Report to Development Permit Panel

Re: Application by Yamamoto Architecture Inc. for a Development Permit at
9431, 9451, 9471 and 9491 Williams Road

**Excerpt from the Minutes from
The Design Panel Meeting**

SCALE: 1/8" = 1'-0"	SHEET NO.
DATE: JAN. 28, 2013	A5.0
DRAWN: NP	CHECKED:
PHOTO: 1108

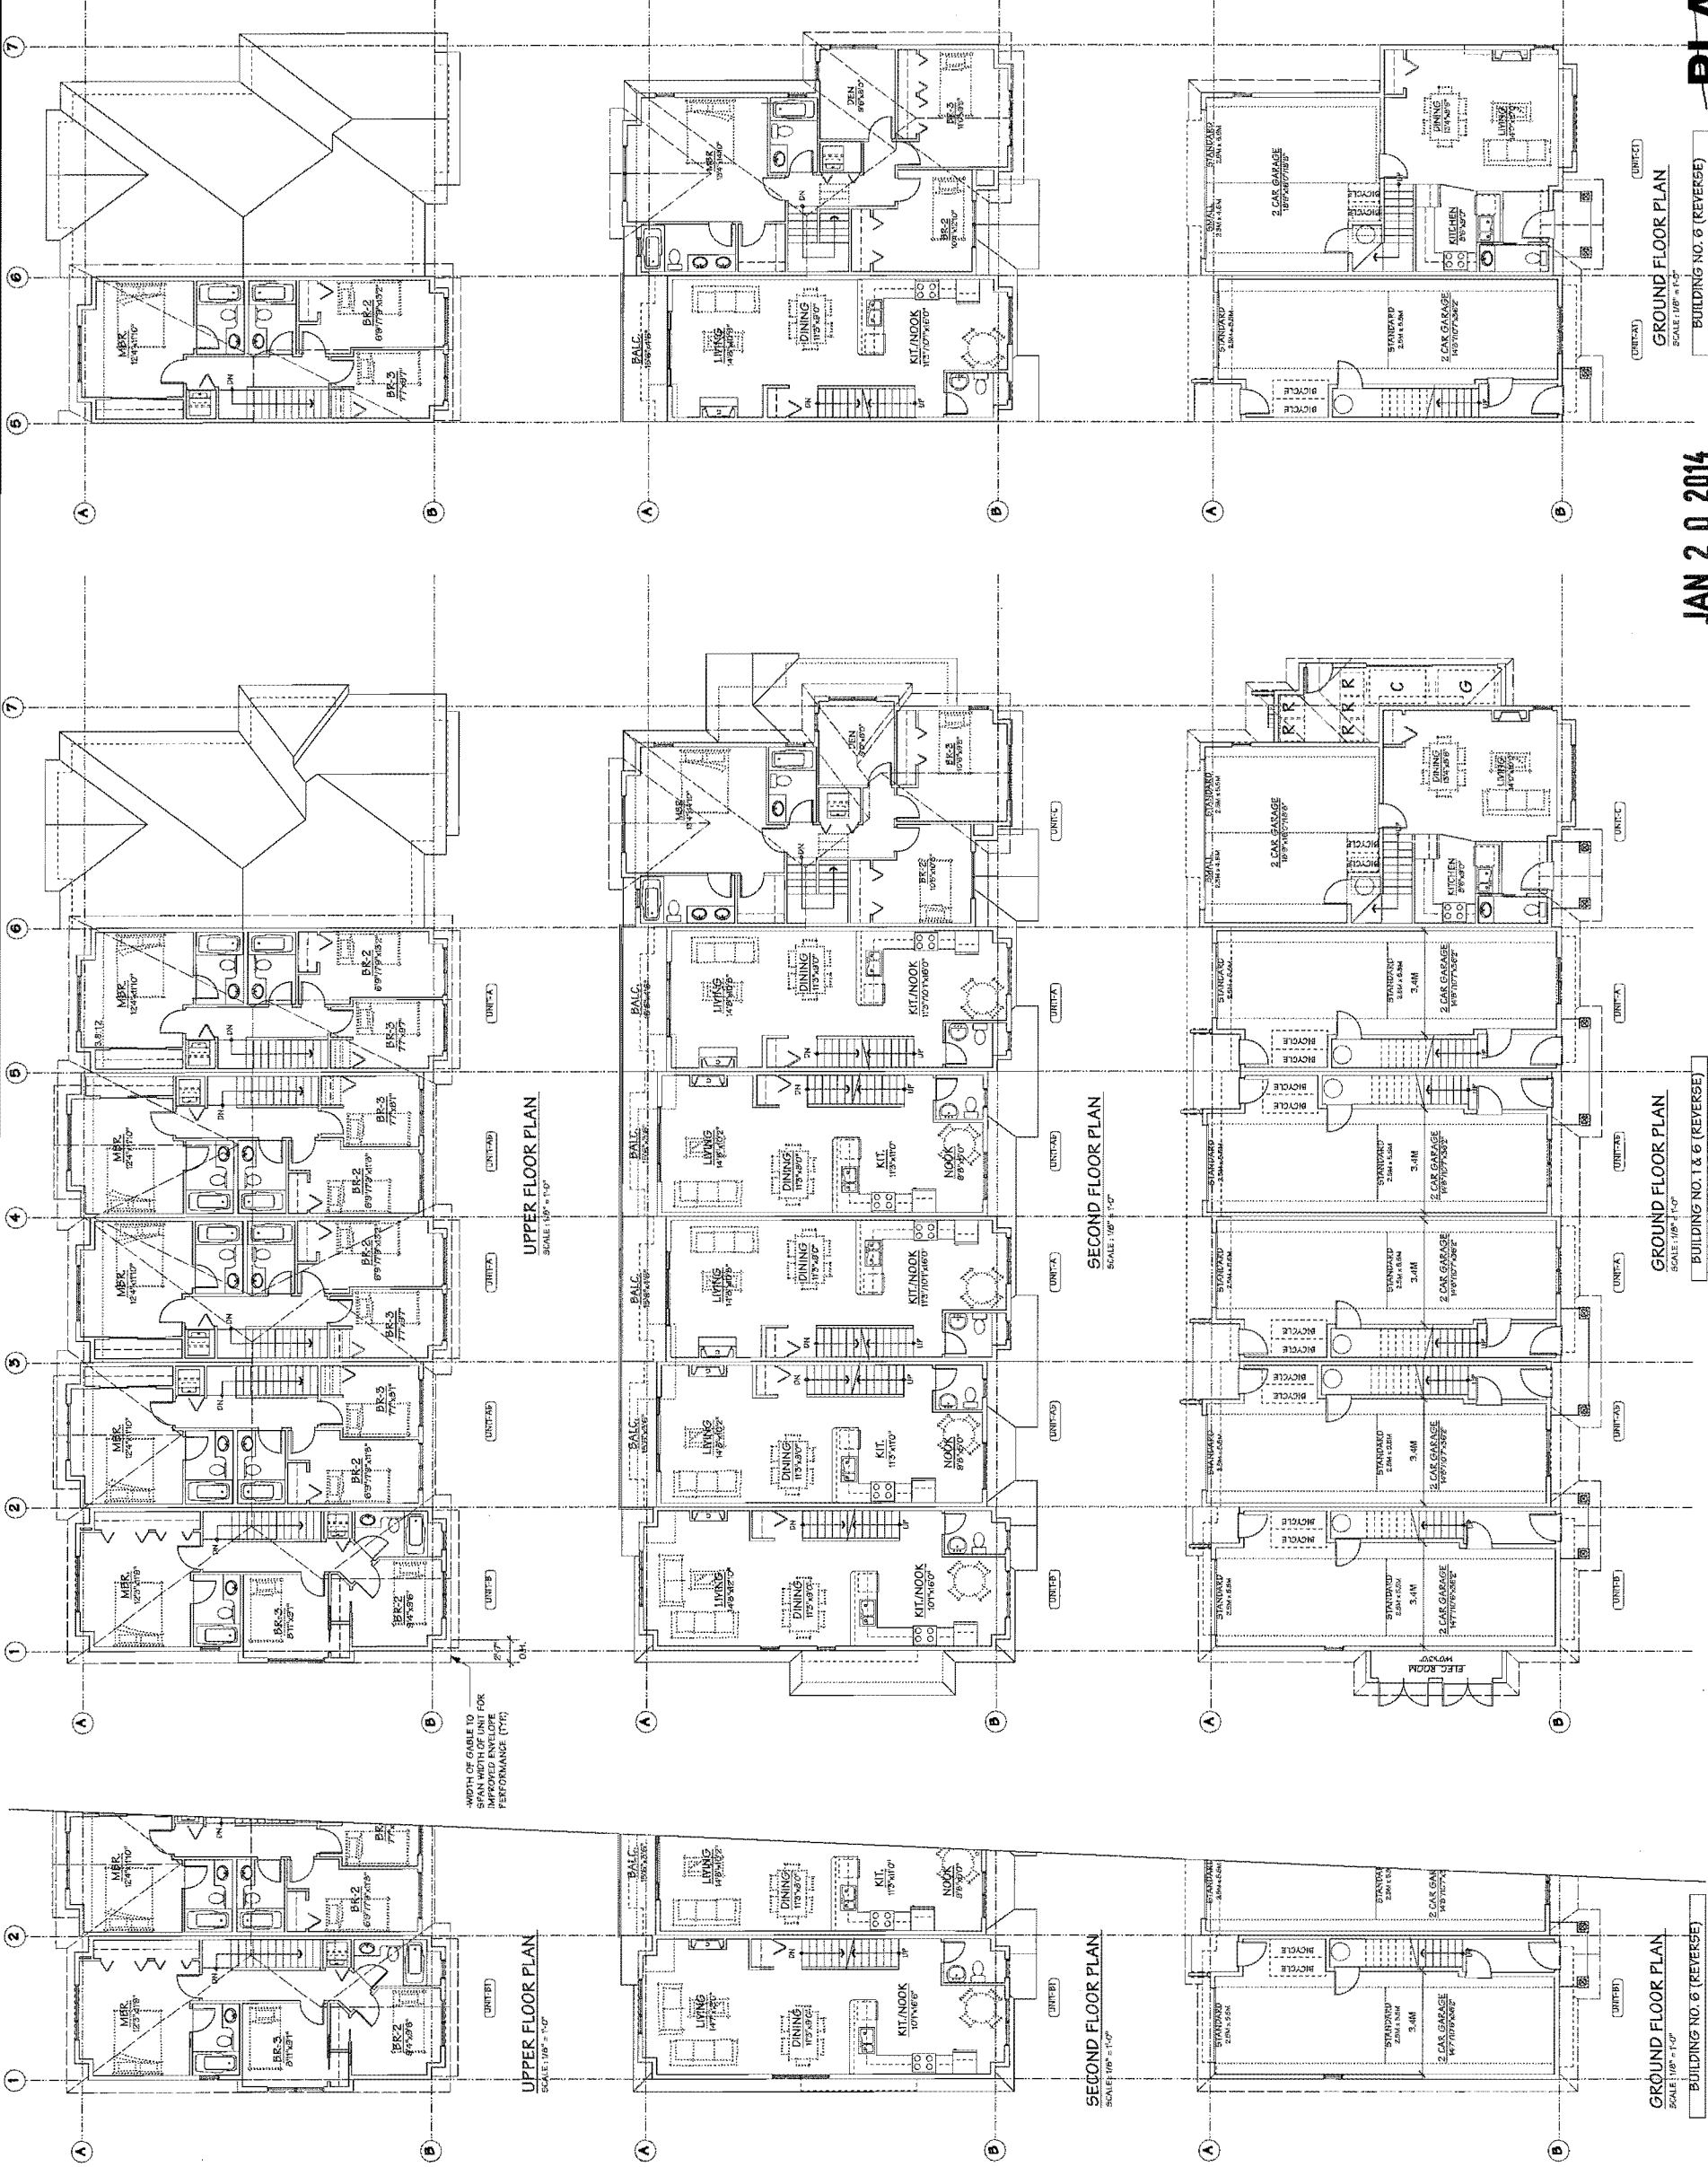
3. consider pocket doors in standard units to create more floor space and enhance accessibility;
Pocket doors integrated at closets for secondary bedrooms in Unit B and linen closet of 2 storey units. See sheet A5.0-5.1.
